Bramford to Twinstead Reinforcement

Volume 8: Examination Submissions

Document 8.3.9: Applicant's Response to Issue Specific Hearing 1
Action Points

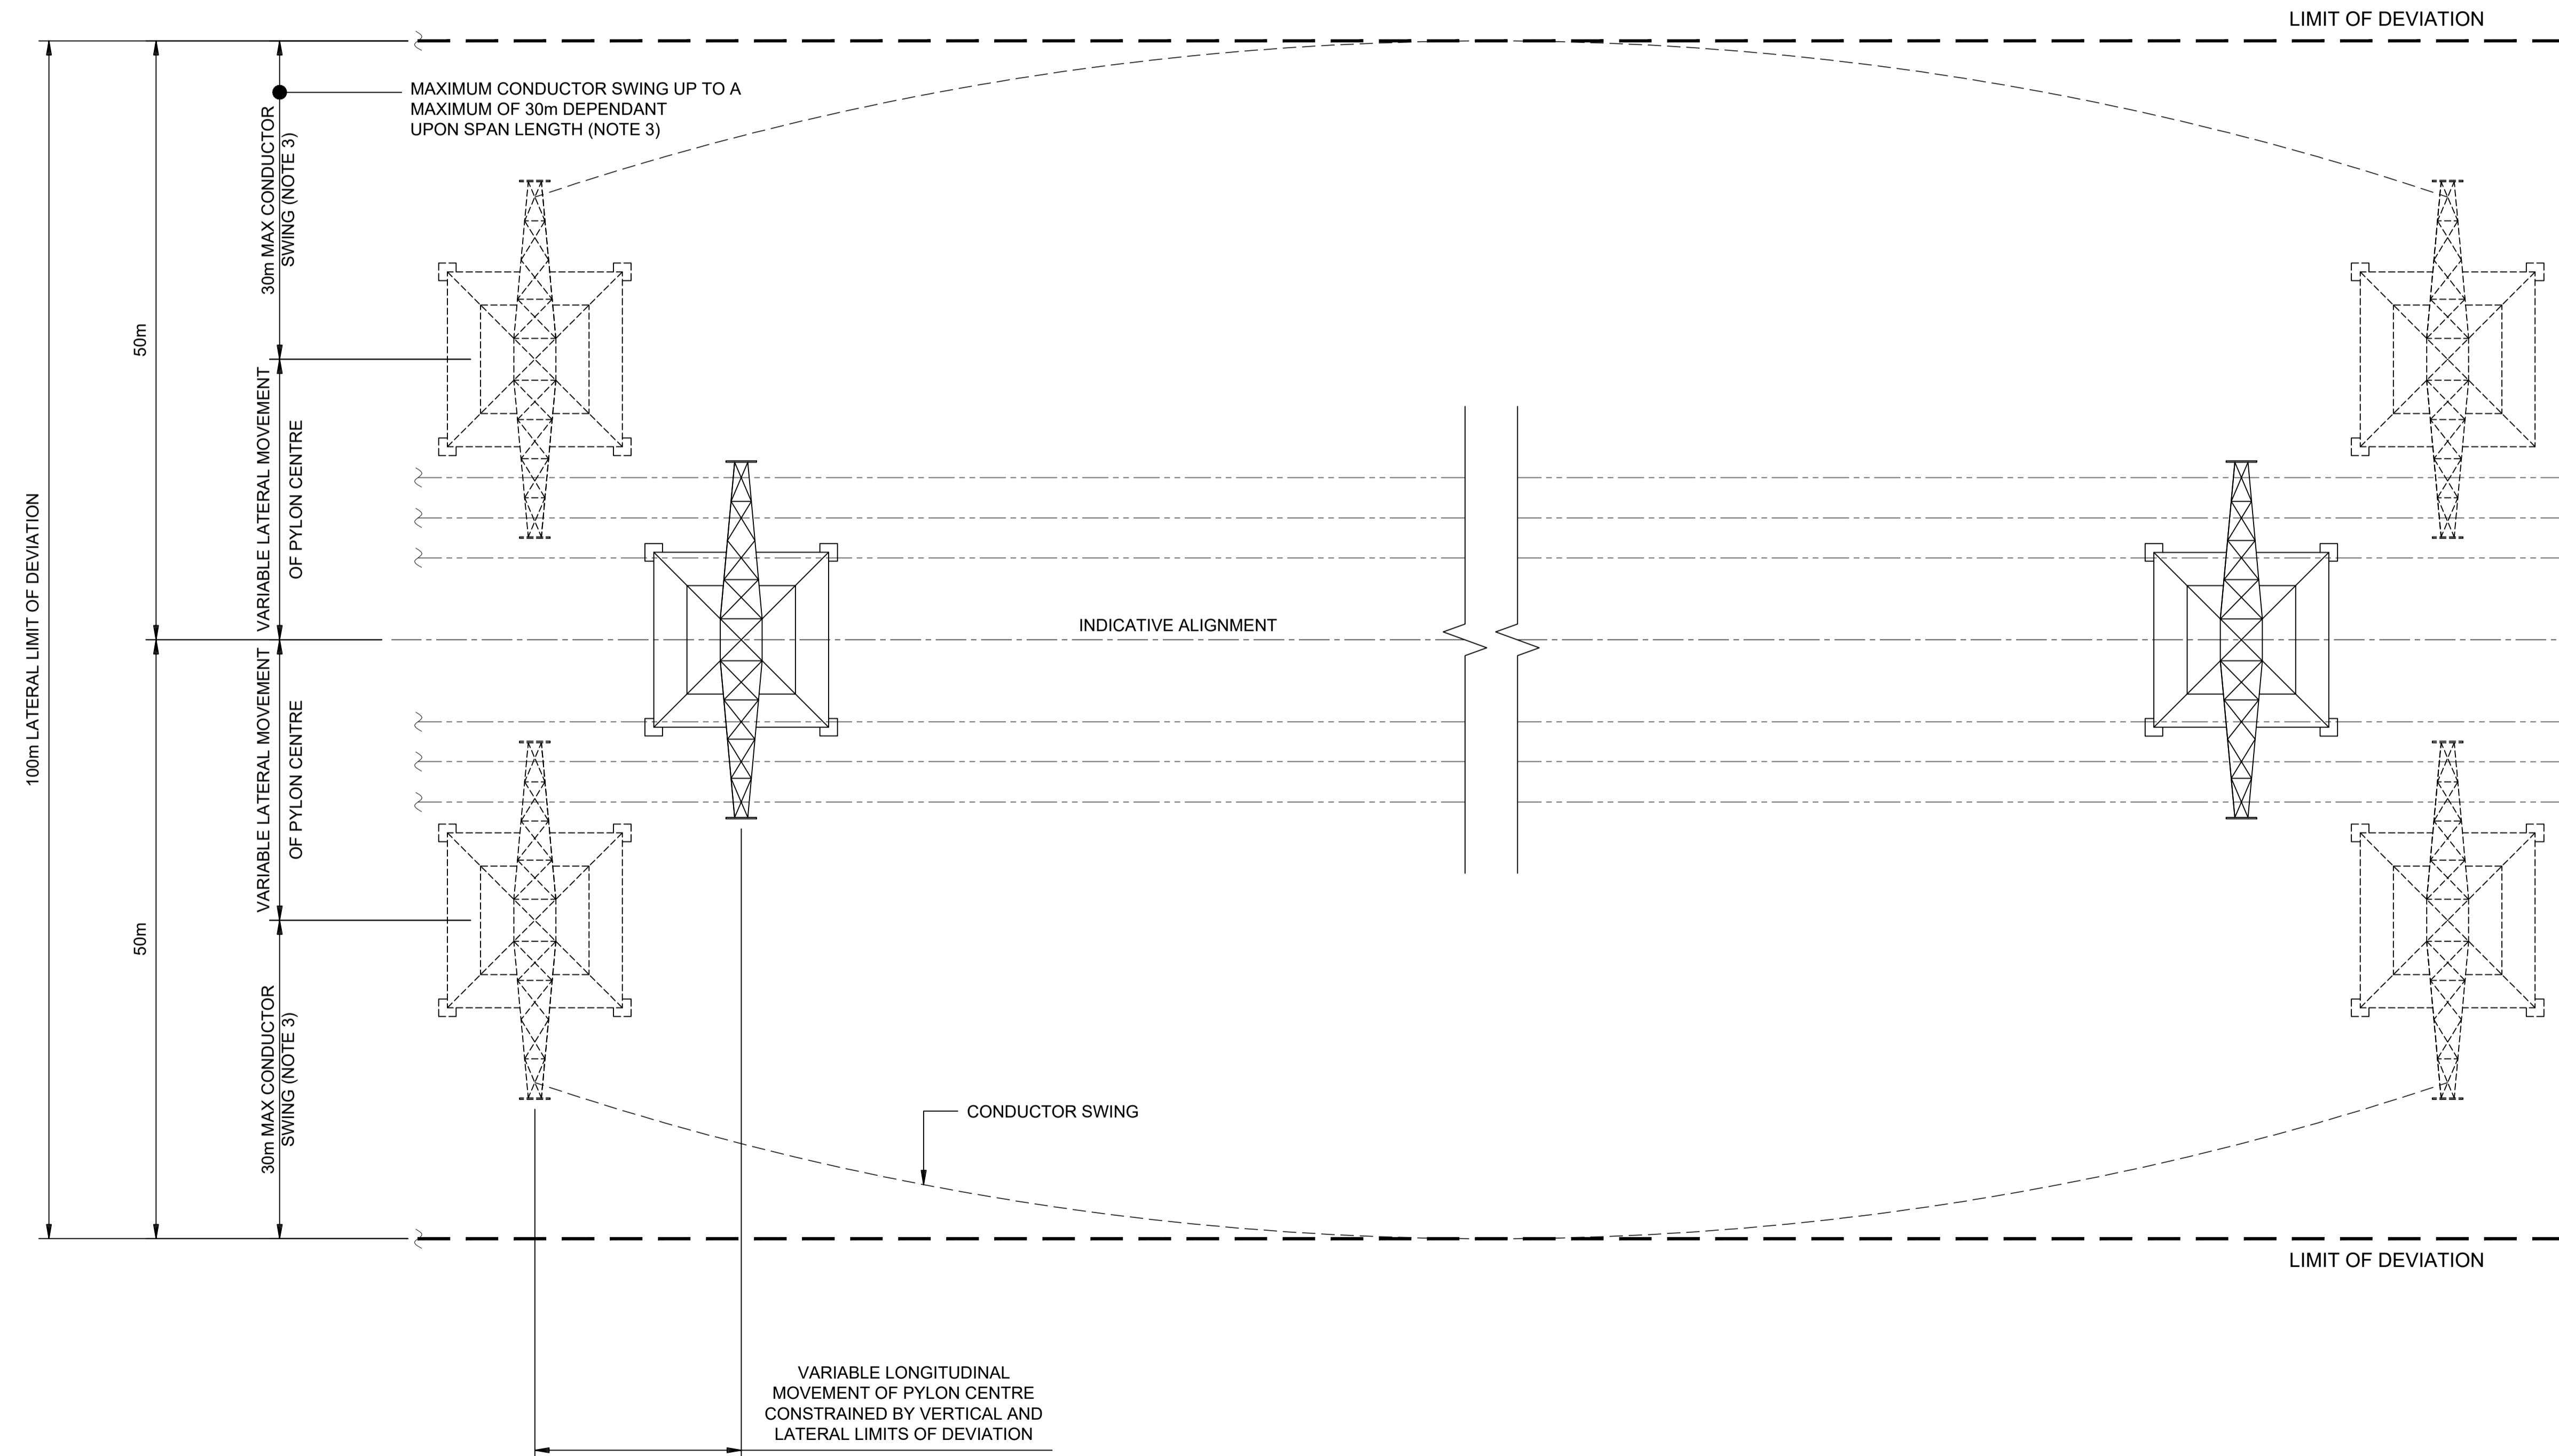
AP4	Supply a drawing and concise note to explain the approach to setting the proposed Limits of Deviation (LoD).	<p>The design principles upon which the overhead line LoD are derived is illustrated on Design and Layout Plan: Limits of Deviation Principles drawing supplied at Appendix A. The overall LoD width comprises two component parts; adjustment of the pylon position and also an allowance for the conductors being blown out under a high wind condition.</p> <p>Regarding an explanation of blown conductor dimensions, based on the current design, the maximum span length is proposed span RB46-47 at 483.34m, with a conductor sag of 19.76m presented for the longest (middle) crossarm. This span length could alter if pylon position adjustment or reconfiguration is required.</p> <p>The suspension insulator sets on proposed pylons RB46 and RB47 hang vertically from the crossarm and will be approximately 5m in length, therefore the overall depth of sag from crossarm level will be approximately 24.76m. The assessment assumes that the conductor (and insulator) could be blown out at a maximum of 45°, resulting in a horizontal offset of 17.51m. When a radial safety clearance of 5.3m is added to this value, the extent of the blown condition in this instance is a total of 22.81m.</p> <p>A total of 30m has been allowed as shown in the Drawing contained at Appendix A for the conductor swing as a worst case, therefore, in practical terms, the maximum distance that a pylon can be adjusted away from the route centreline is 20m. This distance allows for the various design and construction related factors that need to be assessed during the detailed design of each pylon position and a degree of flexibility to account for any variations later found to be necessary during construction.</p>	N/A

- Notes**
1. All dimensions are in metres unless noted otherwise.
 2. The details in this drawing are illustrative only.
 3. Maximum conductor swing is subject to the span length between pylons and is presumed to be under full load on the hottest day of the year with full wind blow out.

TITLE
**Design & Layout Plans:
 Indicative Main Construction Compound**

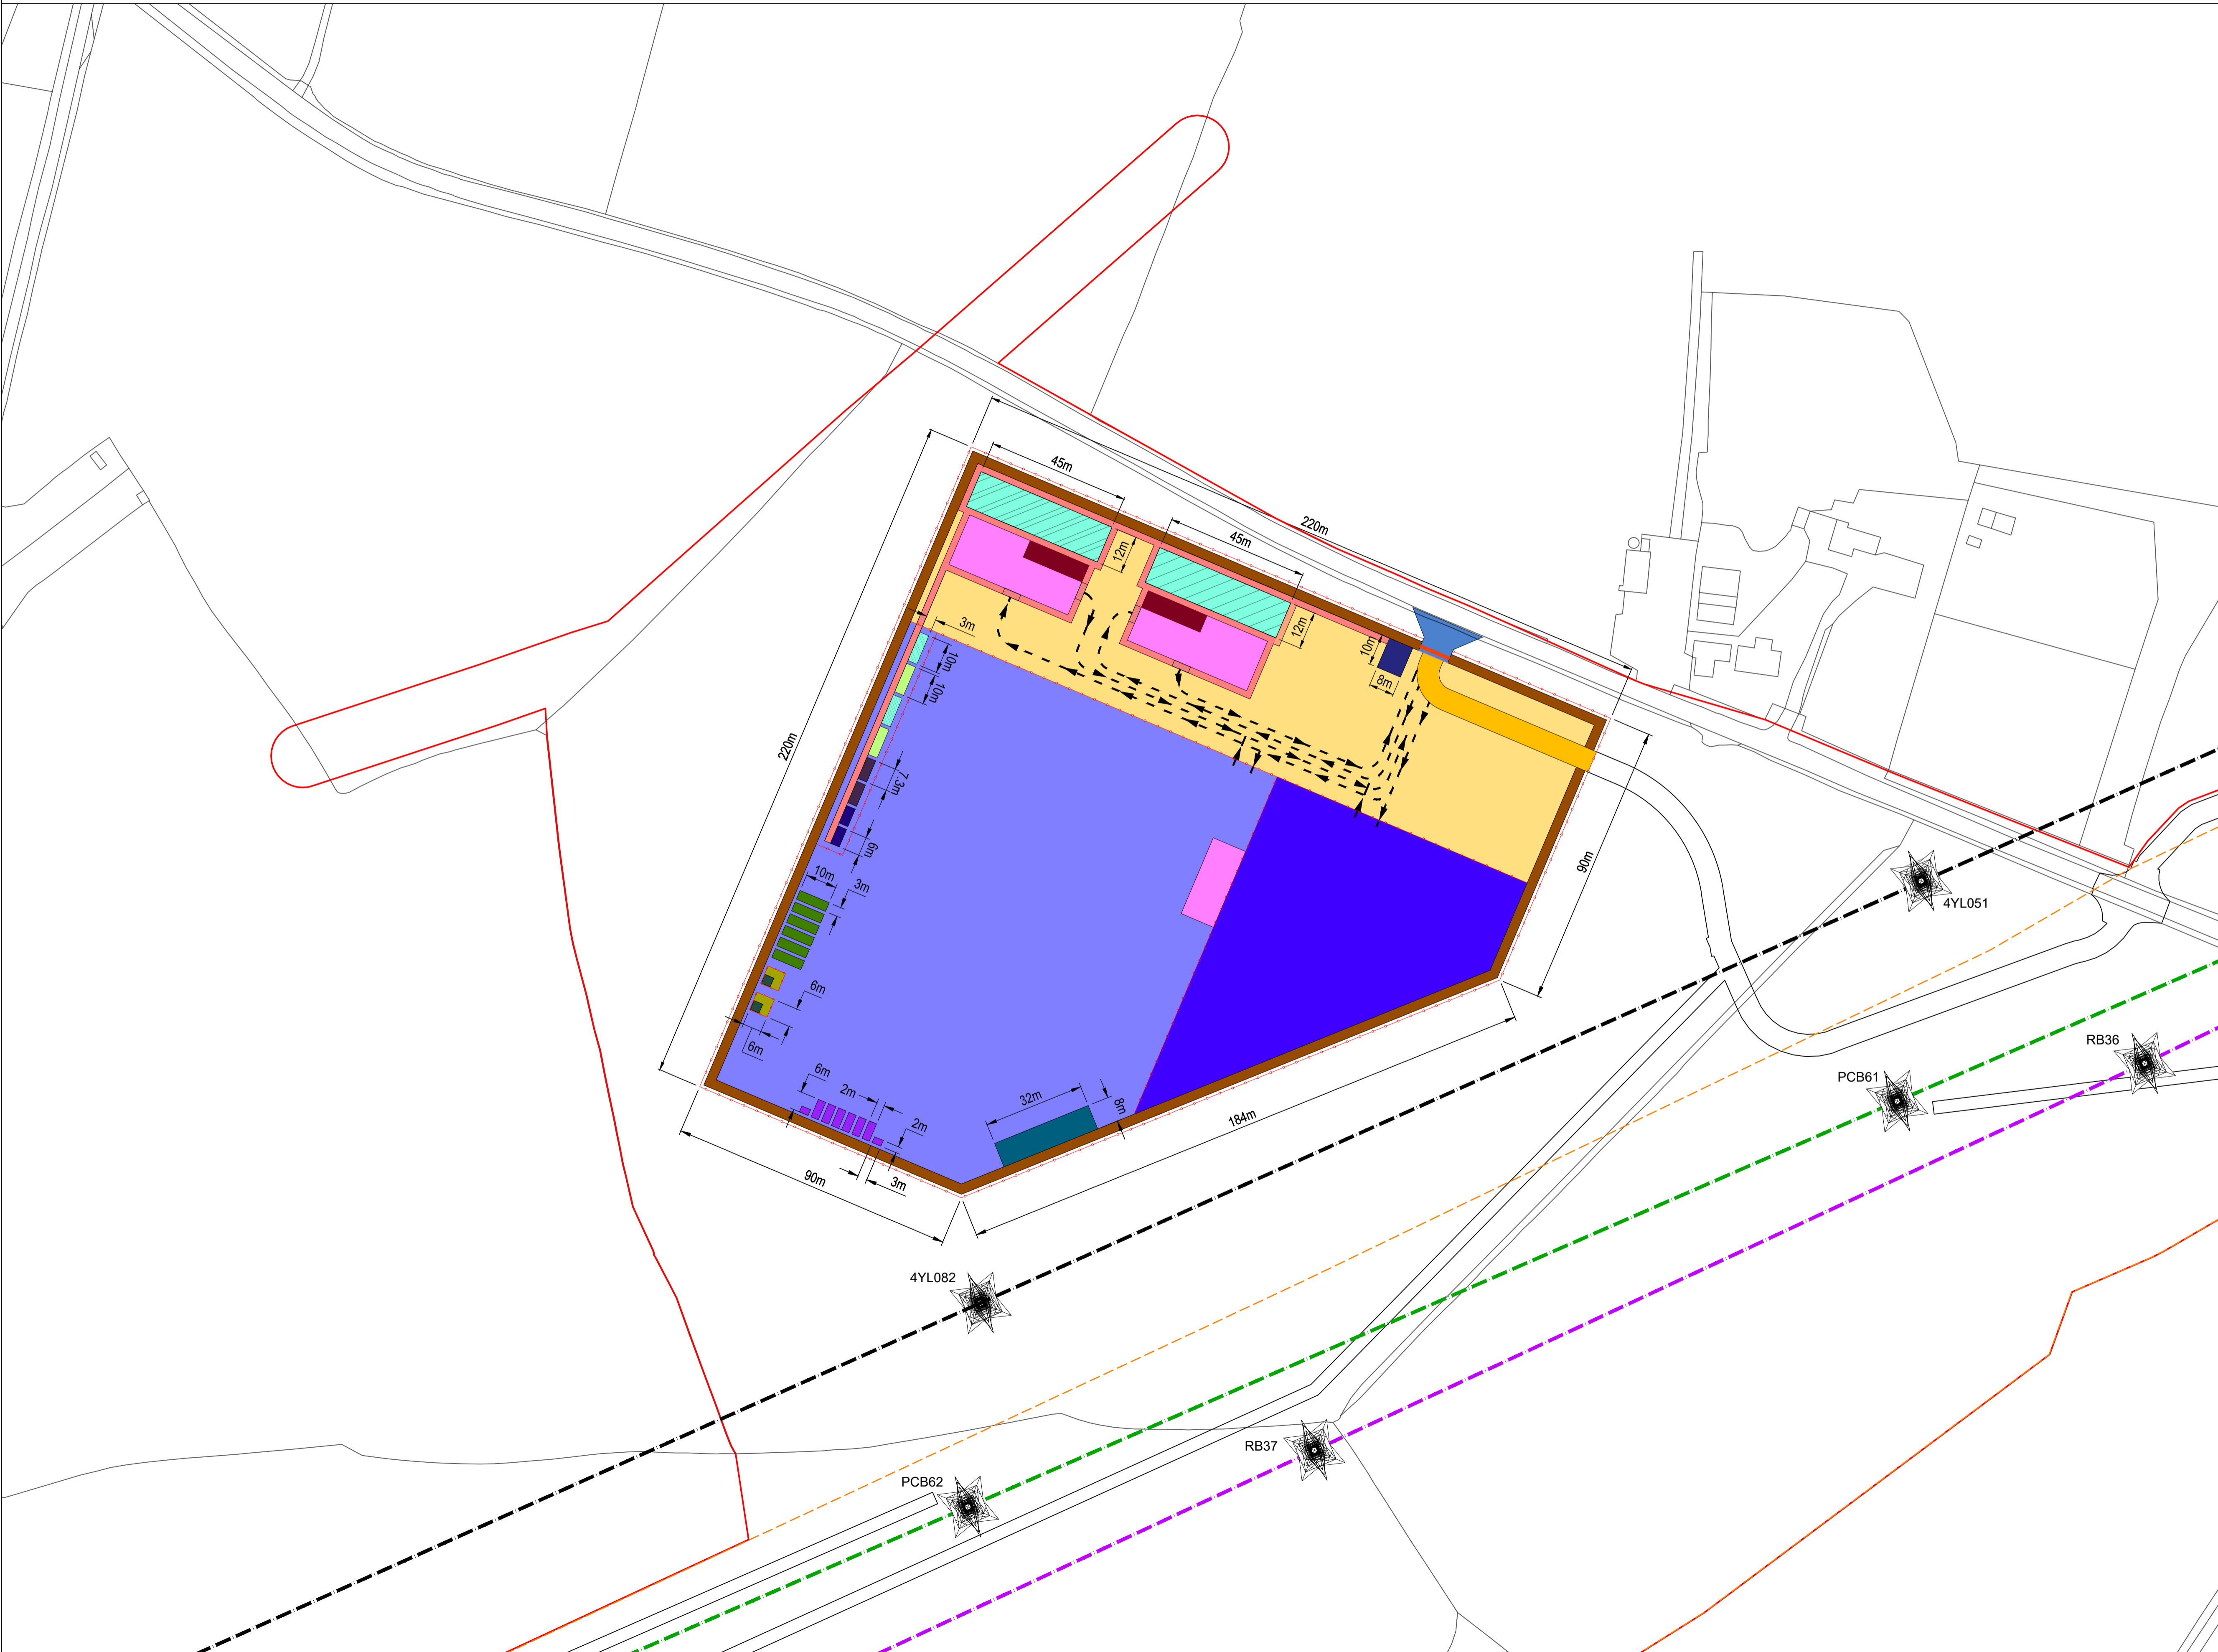
AP8	Provide an indicative layout of the main site compound, including dimensions and the likely height of any structures.	A main site compound is proposed off the A134 at Leavenheath, which would include the site offices, storage areas, parking (including electric vehicles charging points if appropriate) and welfare facilities. An Indicative Main Construction Compound drawing is provided at Appendix B . It is envisaged that the Main Works Contractor would use single story cabins; it is not anticipated that any buildings or stationary apparatus would exceed 7m. However, the main works contractor requires flexibility in their design to use double stacked cabins and other equipment if required. Smaller satellite compounds would be required at the locations listed in Table 4.3 of ES Chapter 4: Project Description [APP-072]. These are anticipated to include storage for soil, machinery and other materials, parking, local welfare facilities and waste management facilities. The proposed construction compounds that have been assumed in the ES are shown on ES Figure 4.1: The Project [APP-072].	Deadline 1

- All dimensions are in metres unless noted otherwise.
- The details in this drawing are illustrative only. The final position and design will be within the parameters contained within the DCO with reference to the Work Plans.
- The maximum height of cabins can be two high and would not exceed 7m.
